# DOS LAGOS - LOT C

## PRELIMINARY STORM, SEWER, & WATER PLANS

DRAWING  
**C2.1**  
SHEET 02  
OF 03

DRAWING  
**C2.2**  
SHEET 03  
OF 03

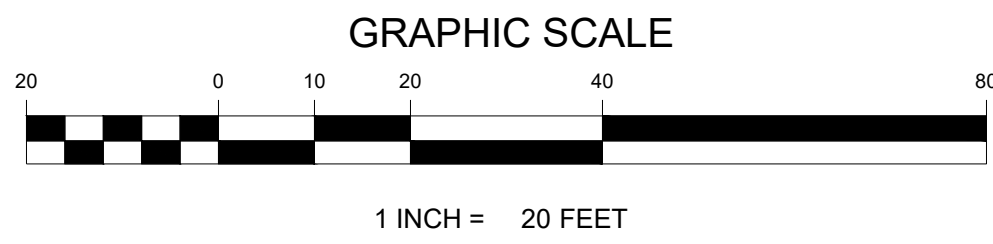
Provide ALTA Survey as supporting documentation for the Preliminary Site Plan Application

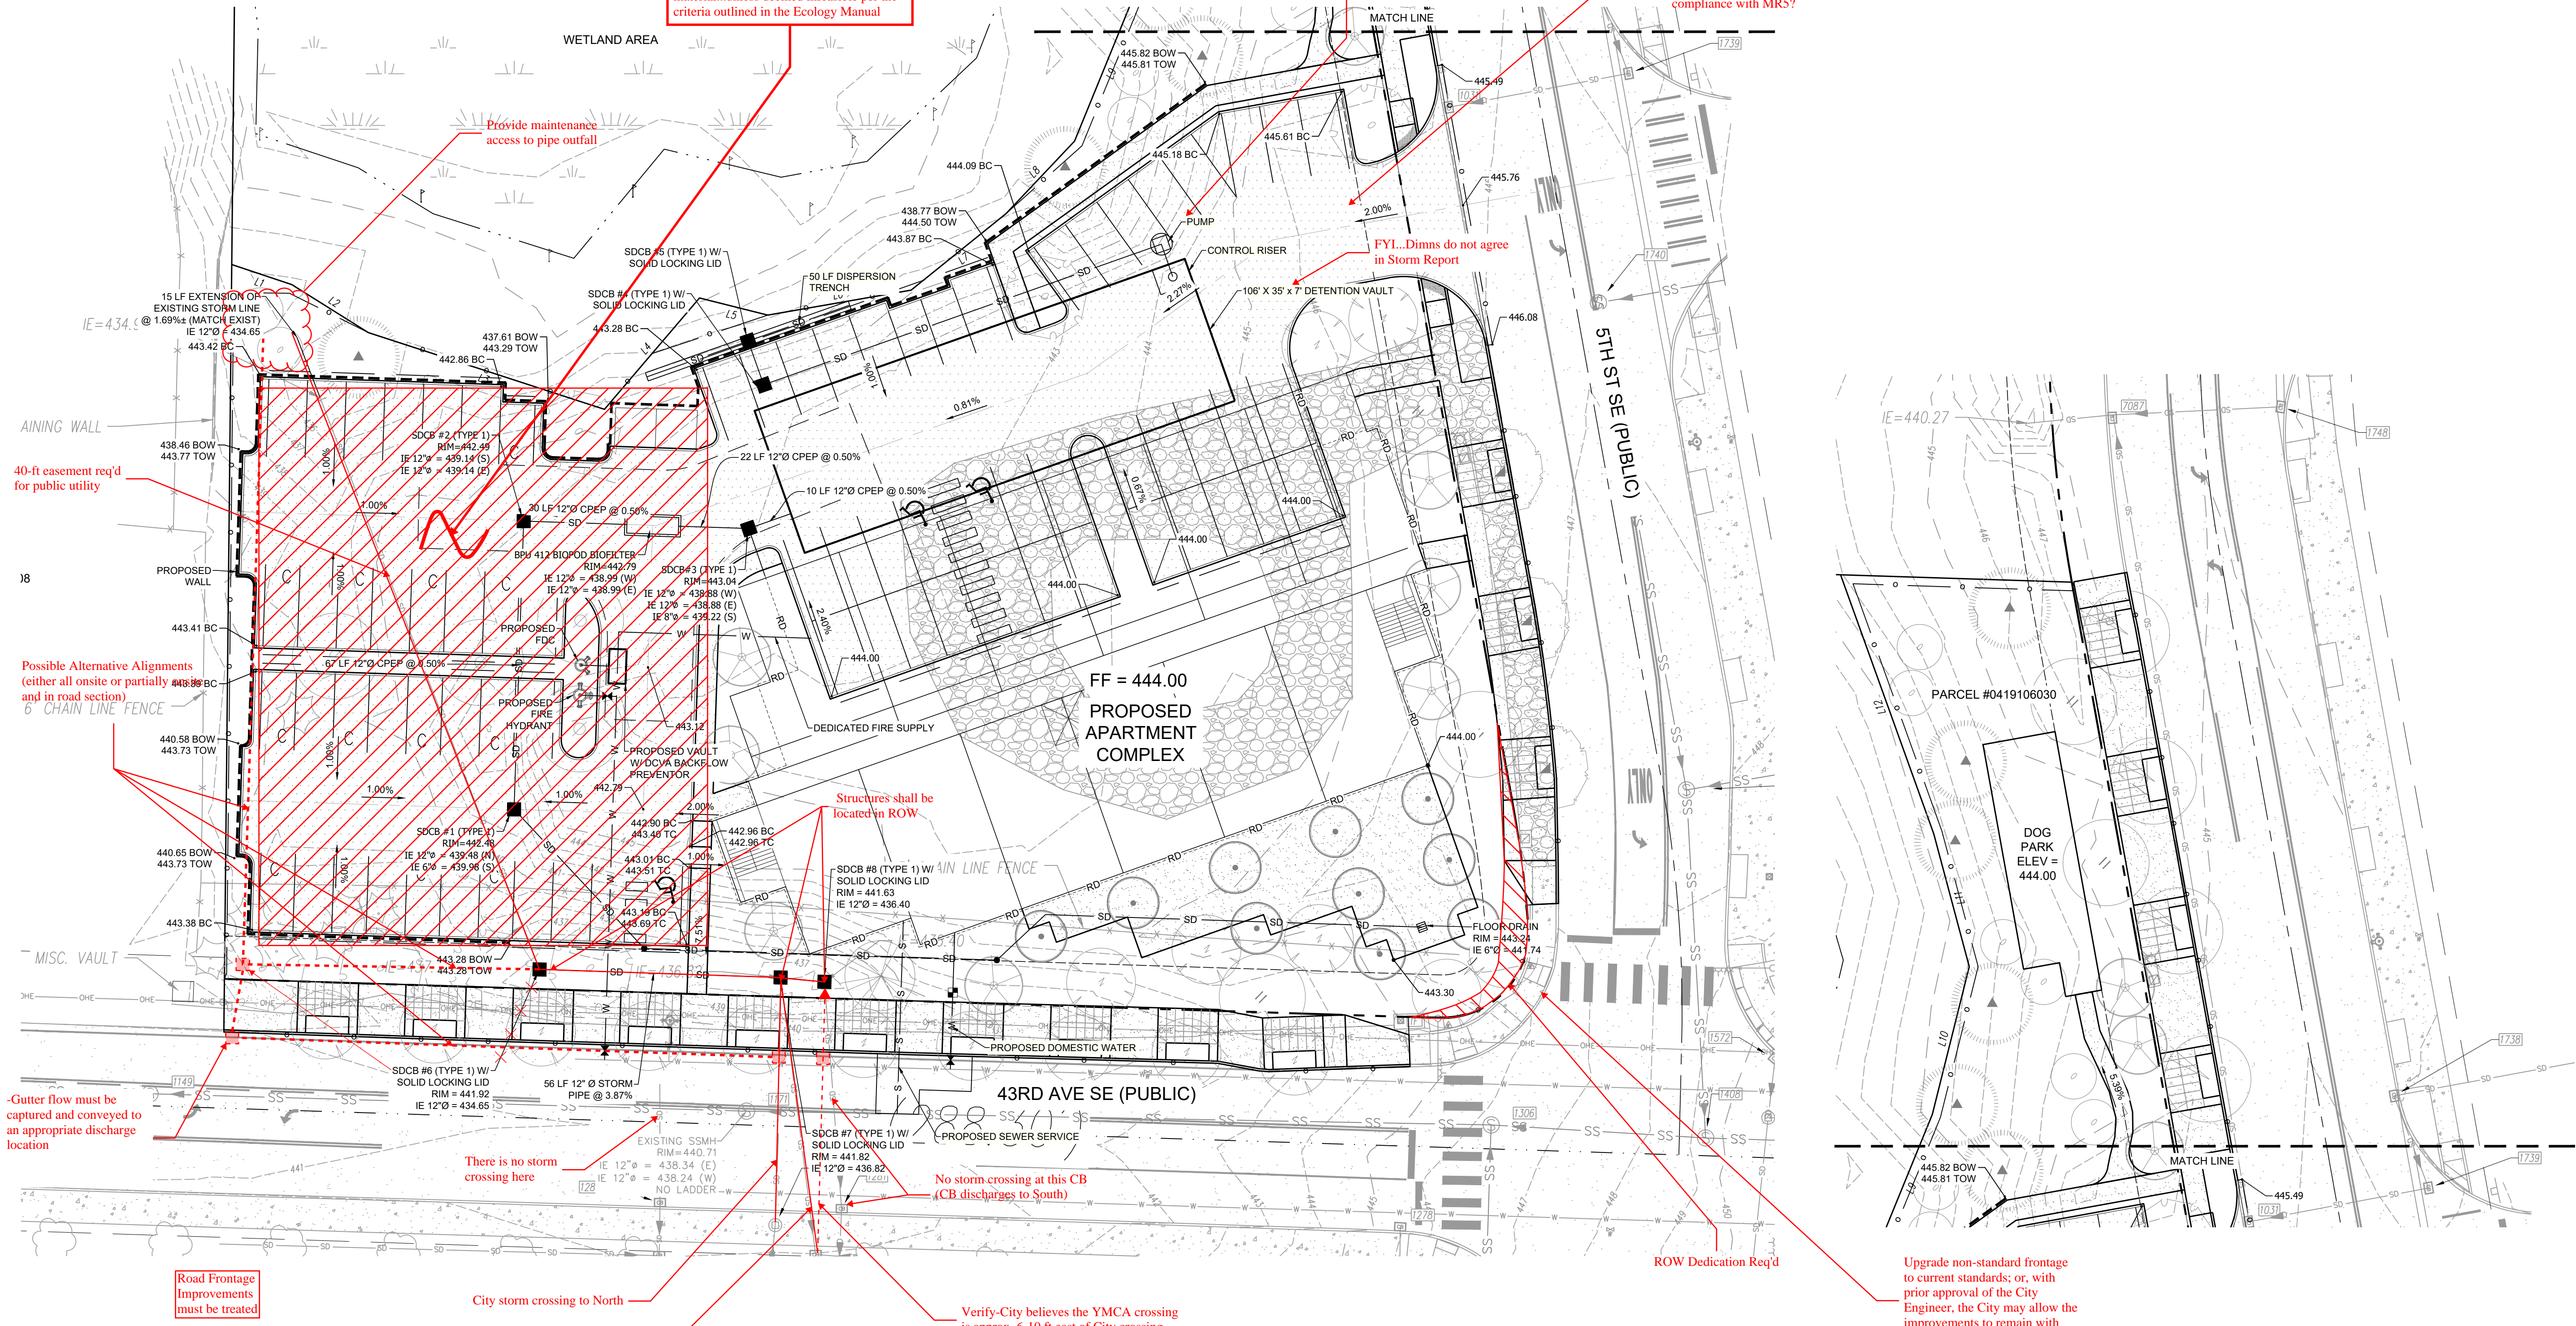
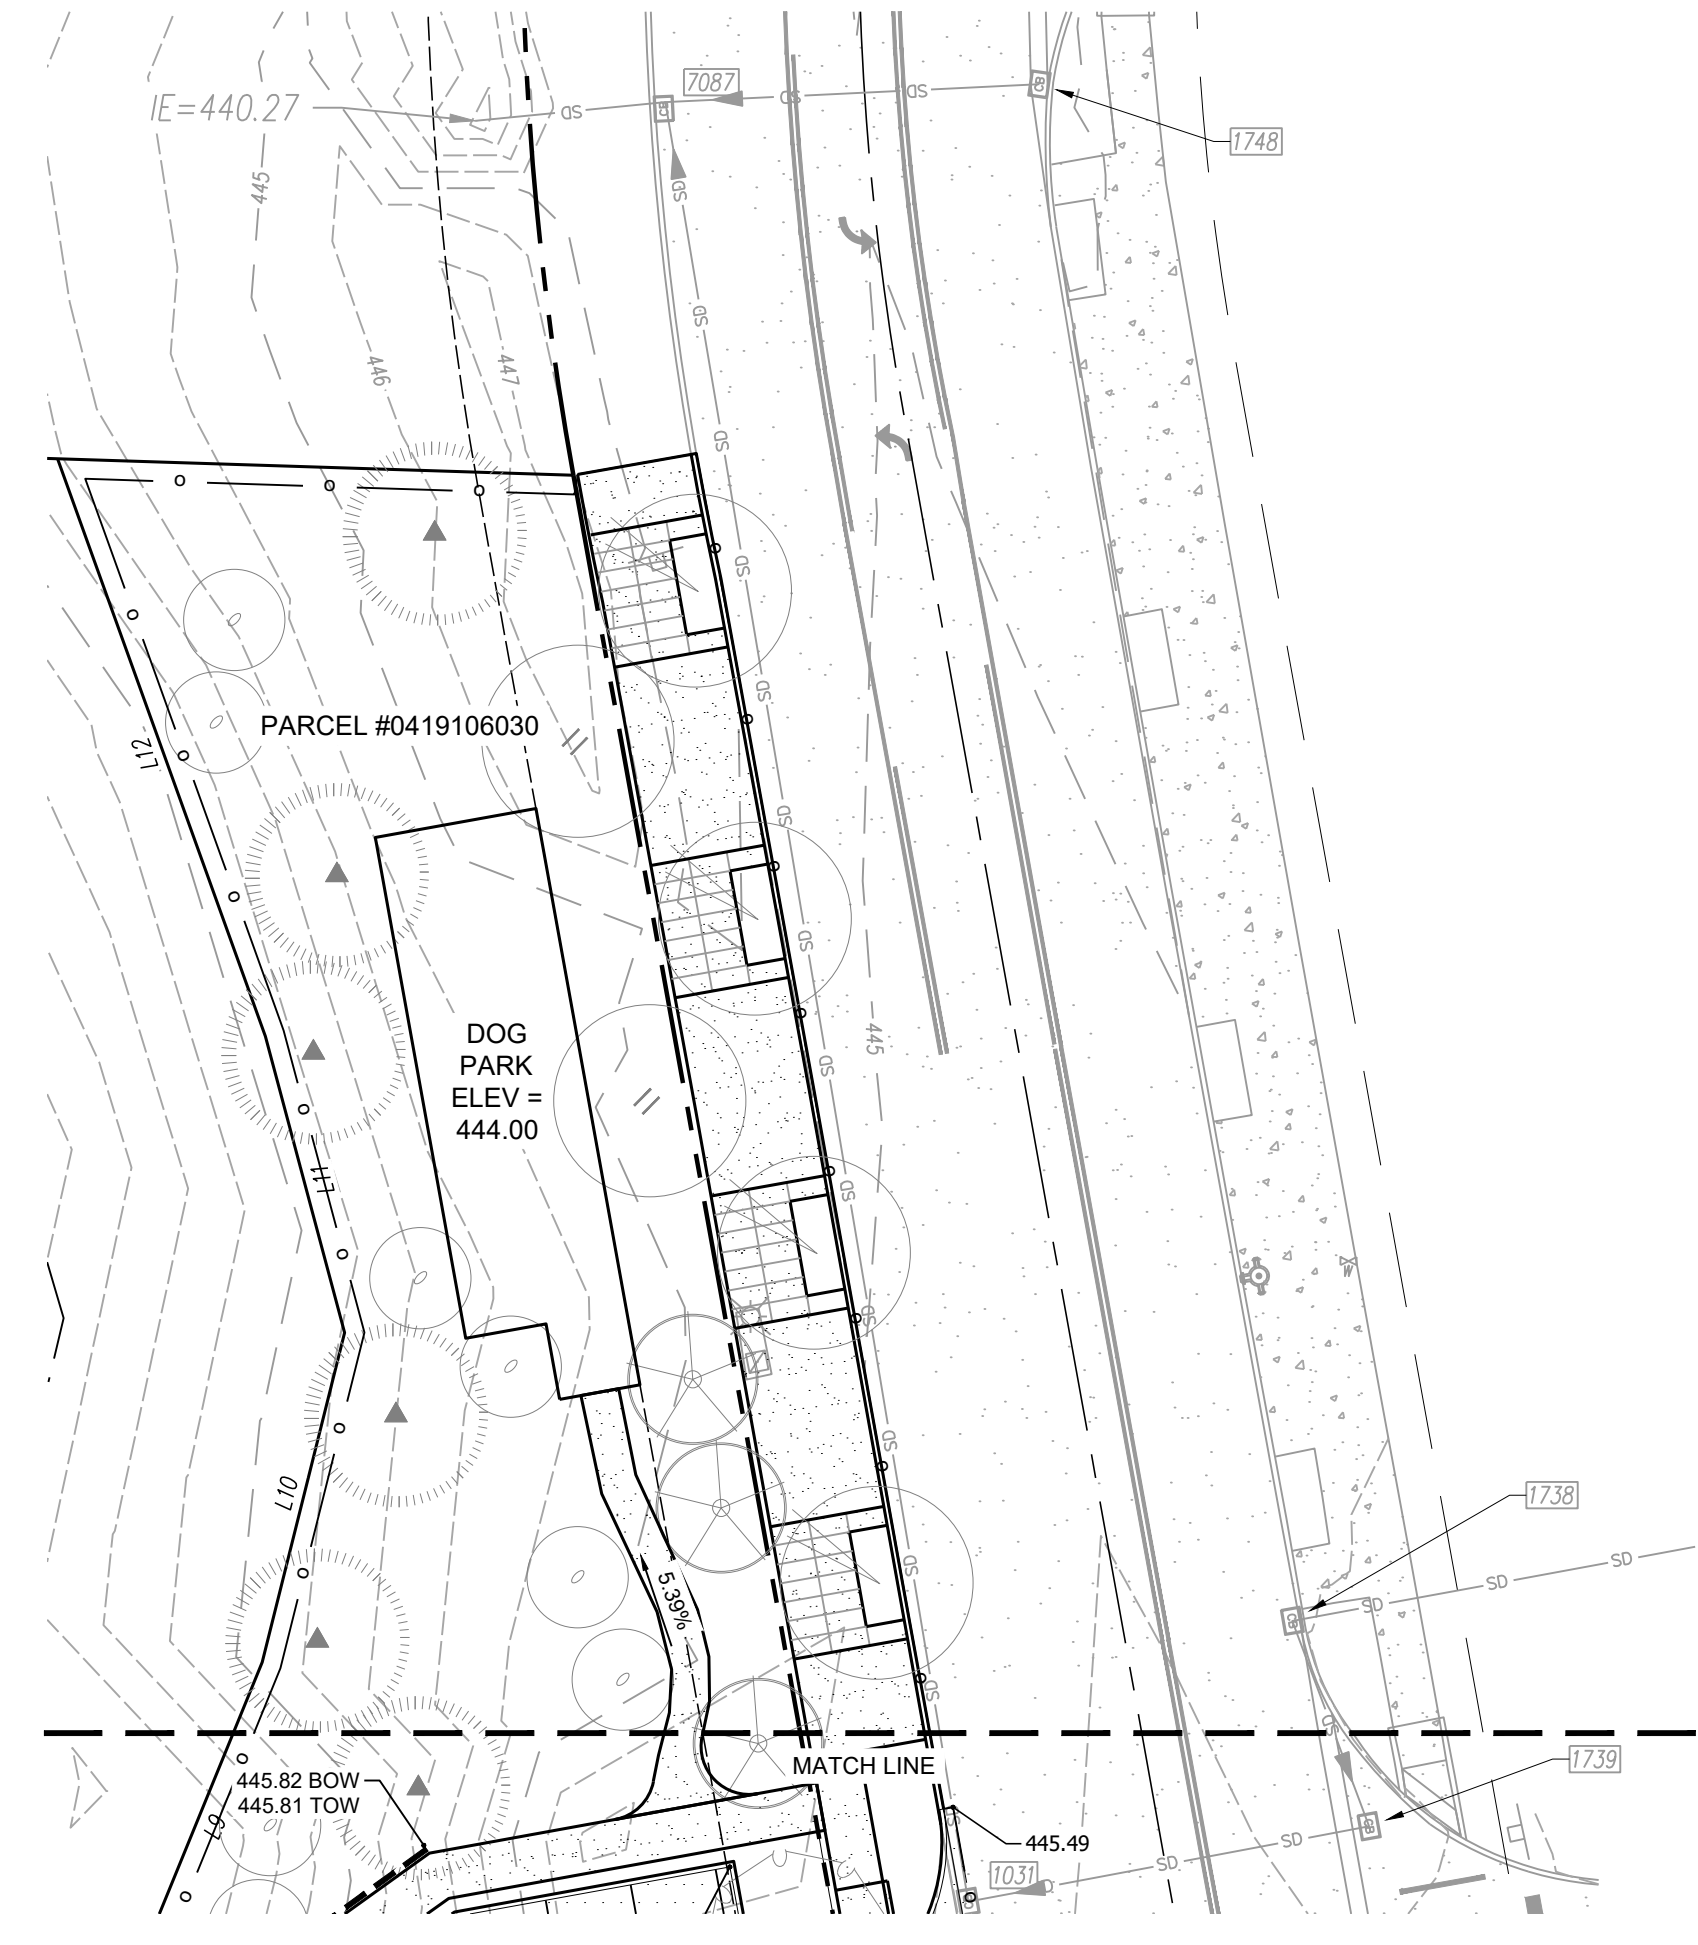
-Due to the pump being located downstream of the control riser, provide preliminary calculations showing the proposed pump system curves comply with the Duration Standard (MR7).  
-Also, refer to City Standard 204.7 for criteria associated with pump systems  
-Considering the depth of the proposed vault, infiltration into the Everett-Neilson soils may be a possible alternative to the proposed pump system...provided wet season testing into the infiltrative stratum confirms feasibility.

-Clarify if the design intent is to retain or remove the existing fill on this site. If removed, is import to support the use of permeable pavement (MRS) infeasible per the criteria in the Ecology Manual?  
-If fill is to remain, what Ecology infeasibility criteria negates its use for compliance with MRS?

The grade is being raised substantially in this area which may allow the use of permeable pavement (MRS) with the import of permeable fill and reservoir course material...unless deemed infeasible per the criteria outlined in the Ecology Manual

Provide maintenance access to pipe outfall

FYI...Dimms do not agree in Storm Report

40-ft easement req'd for public utility

Possible Alternative Alignments (either all onsite or partially on and in road section)

Gutter flow must be captured and conveyed to an appropriate discharge location

There is no storm crossing here

No storm crossing at this CB (CB discharges to South)

Road Frontage Improvements must be treated

City storm crossing to North

YMCA storm crossing to North

Verify-City believes the YMCA crossing is approx. 6-10 ft east of City crossing.

ROW Dedication Req'd

Upgrade non-standard frontage to current standards; or, with prior approval of the City Engineer, the City may allow the improvements to remain with the processing of an AMR.
